REVIEW OF WATER DEMAND AND UTILIZATION
STUDIES FOR THE PROVO RIVER DRAINAGE BASIN,
AND REVIEW OF A STUDY OF THE EFFECTS OF THE
PROPOSED JORDANELLE RESERVOIR ON SEEPAGE TO
UNDERGROUND MINES, BONNEVILLE UNIT OF THE
CENTRAL UTAH PROJECT

By K.M. Waddell, G.W. Freethey, D.D. Susong, and G.E. Pyper

U.S. GEOLOGICAL SURVEY
Open-File Report 91-514

Figure 6.0-2--Conceptual diagram of Weber River Divertible Flow Study.

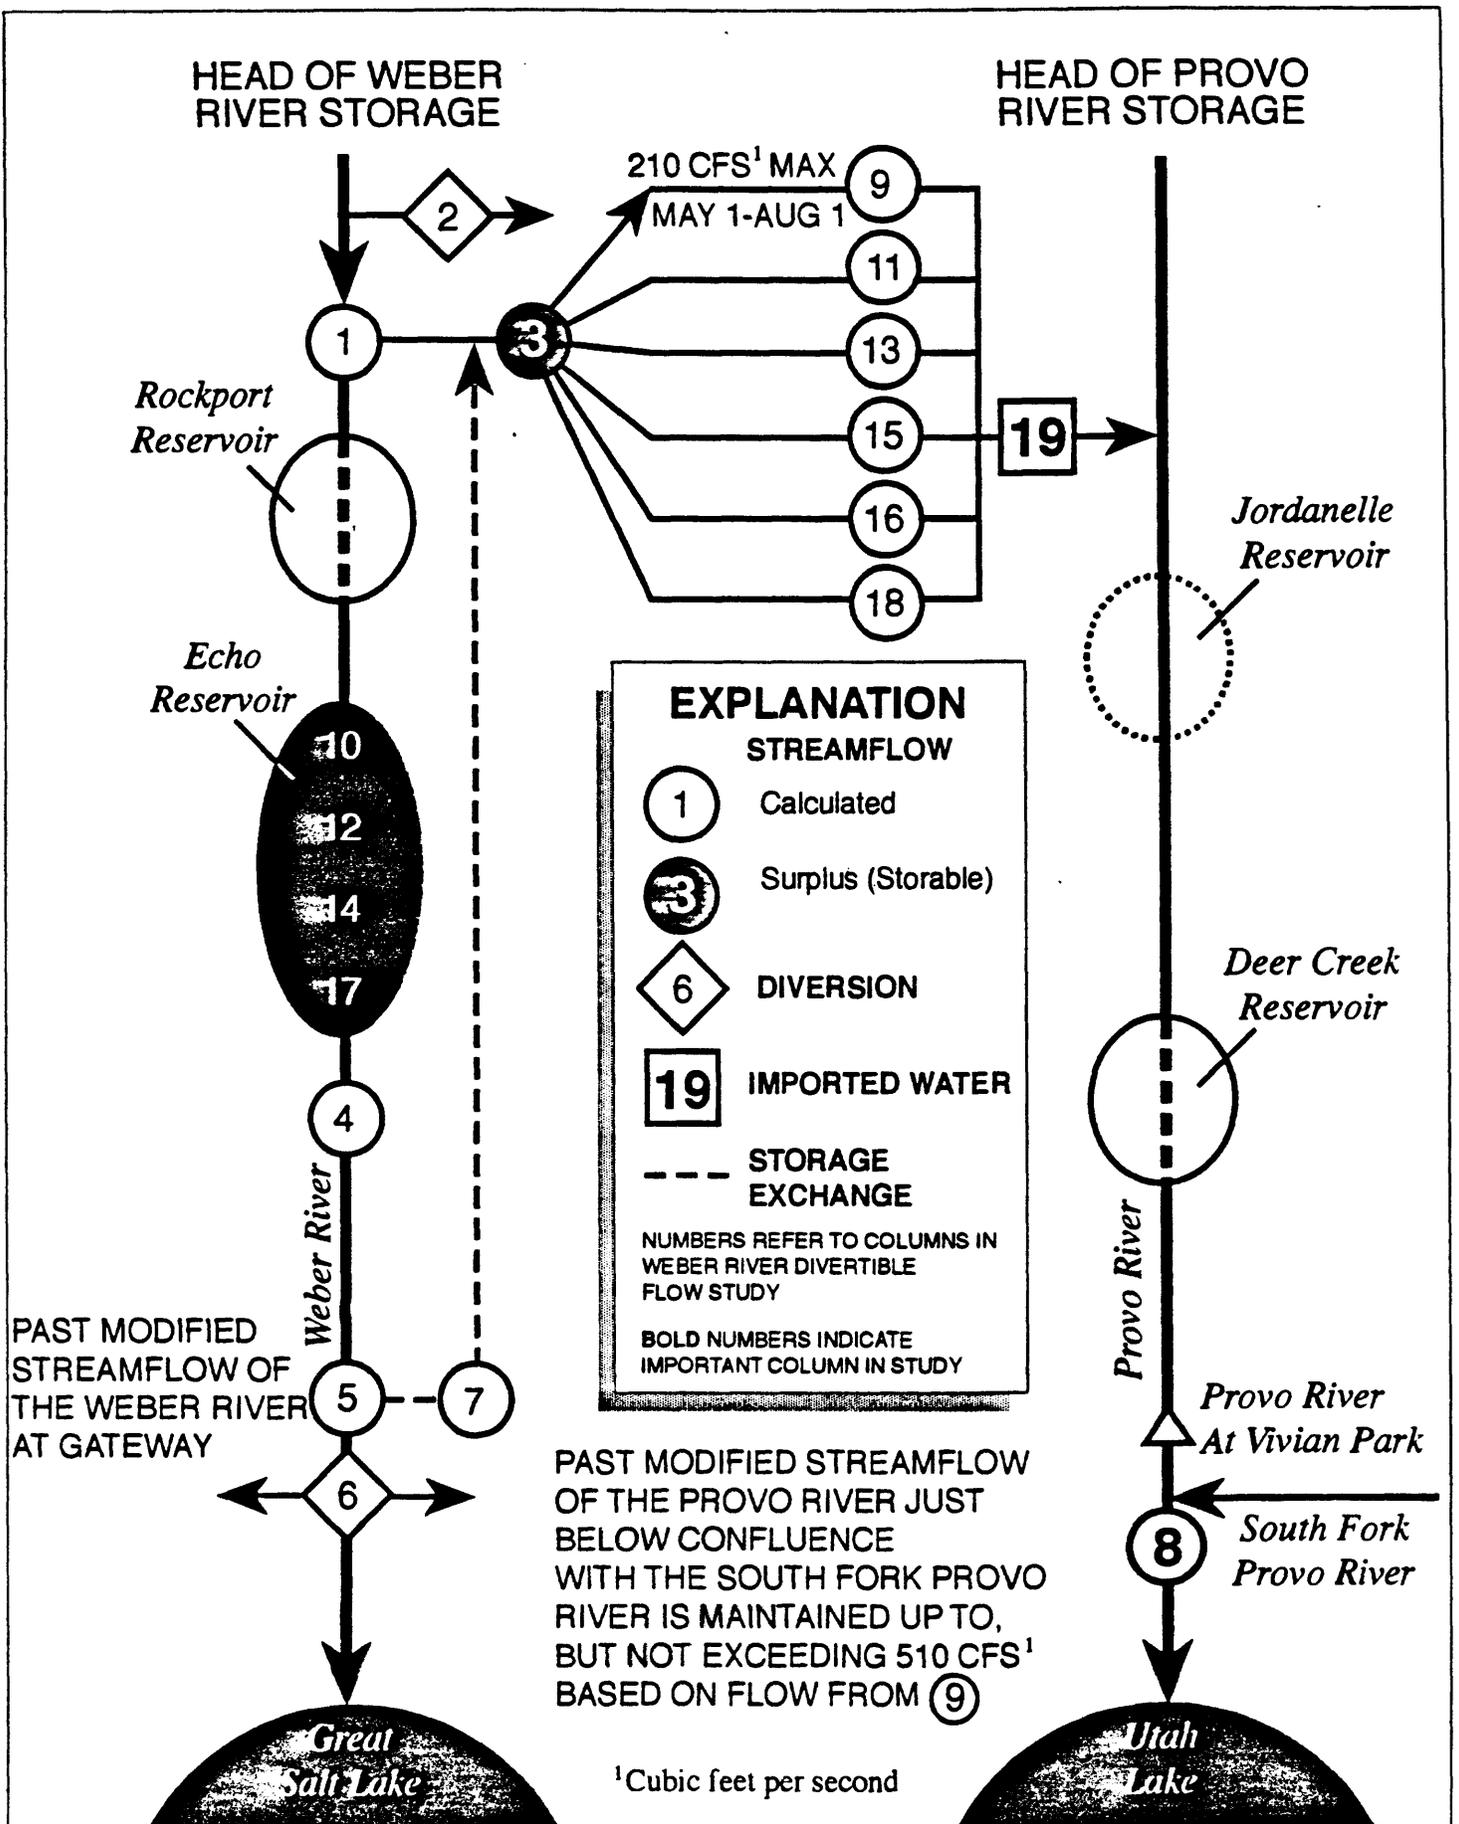
The USGS review of the Weber River Divertible Flow Study consisted of verifying the logic and checking the data values and computations of program columns for the selected years of 1952, 1961, and 1971. A conceptual diagram (fig. 6.0-2) was developed to help verify the logic of the program.

The USGS review of the Weber River Divertible Flow Study determined that the water divertible to the Provo River Project Operation Study was calculated correctly with two minor exceptions. However, these exceptions will not affect the water available for diversion. The exceptions are:

1. In the determination of past modified flow (defined as unmodified flow in the Weber River Divertible Flow Study) of the Weber River at Gateway (USBR, 1975, column 5; reference 38a), Rockport Reservoir storage releases, water deliveries to Ogden Bay Wildlife Refuge, and changes in the content of East Canyon Reservoir were not accounted for correctly. The Rockport Reservoir storage releases are accounted twice—in the past modified flow of the Weber River at Echo Dam which is included in the computation of past modified flow of the Weber River at Gateway. The water deliveries to Ogden Bay Wildlife Refuge are demands that are downstream from the Gateway gaging station and therefore should not be part of the calculation. The change in content of East Canyon Reservoir was included in the calculation only for 1967-73. USGS reviewers believe the change in content also should have been used for 1930-66.

2. The past modified flow in the Provo River below Vivian Park is used to determine the quantity of flow in the Weber-Provo Diversion Canal that is diverted to the Provo River under the Contract of December 16, 1926, part 13(b). A discrepancy exists between the contract and the Draft Supplement to the DPR (USBR, 1988f) as to the location where the 510 cubic feet per second will be maintained. The Draft Supplement to DPR (USBR, 1988f) states that the 510 cubic feet per second of flow is to be maintained at the gage on the Provo River at Vivian Park, whereas the contract indicates that 510 cubic feet per second will be maintained below the confluence of the South Fork of the Provo River and the Provo River.
